DESIGN REVIEW BOARD

DRB2015-24

Design Review for an exterior façade renovation

O'REILLY AUTO PARTS STORE AND DAVITIA HEALTHCARE PARTNERS, COMMERCIAL FAÇADE RENOVATION - 3400 10TH AVENUE SOUTH

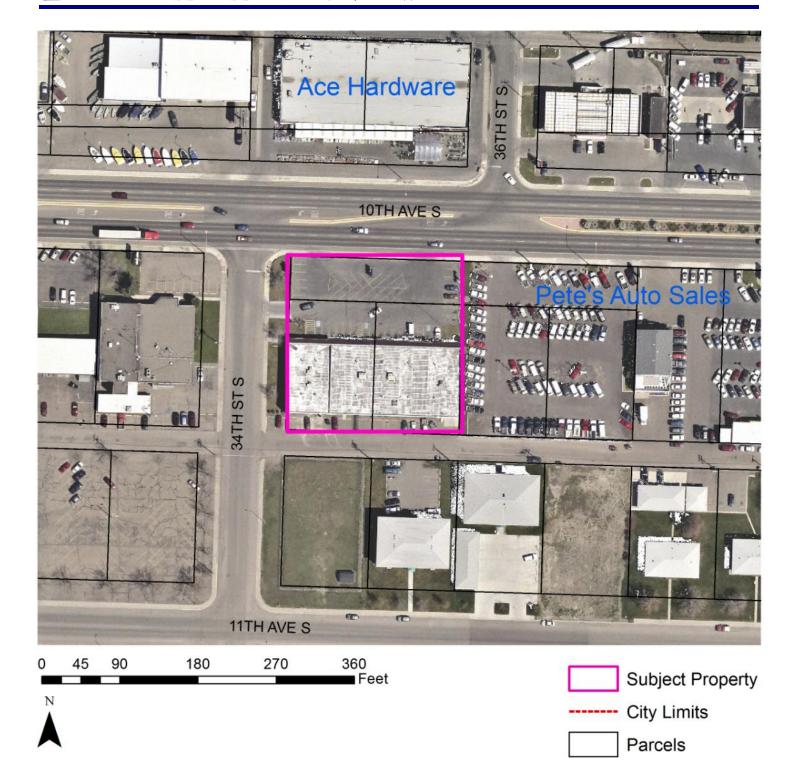
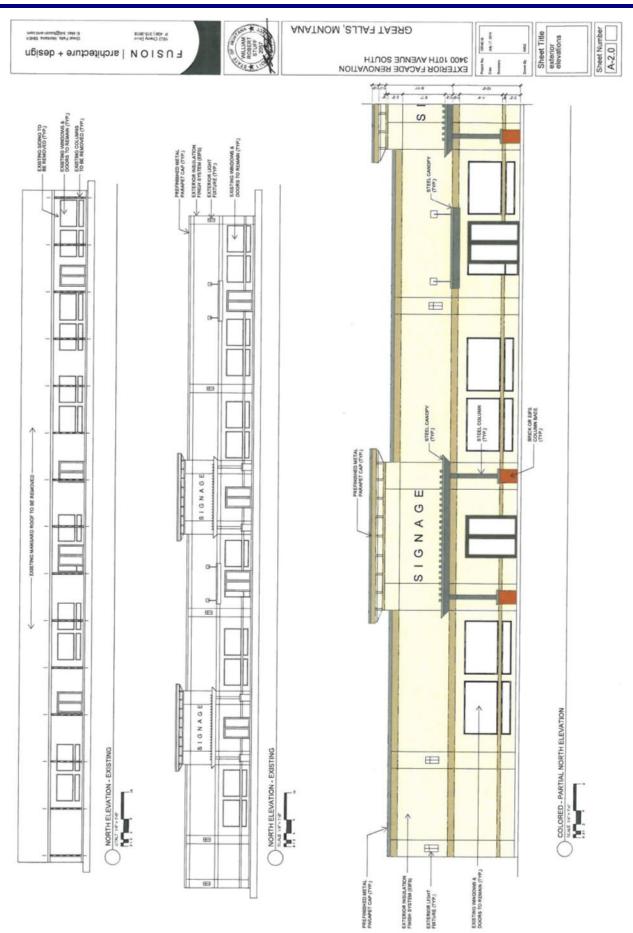
"I move that the Design Review Board (approve/approve with conditions) the Design Review Application for the commercial façade renovation located at 3400 10th Avenue South, as shown in the conceptual development plans contained within this report and provided by the Applicant, subject to the following conditions:

C.	The applicant is required to amend the existing parking area into the existing tracts of land per file memo requested in 1972.	the
_		
_
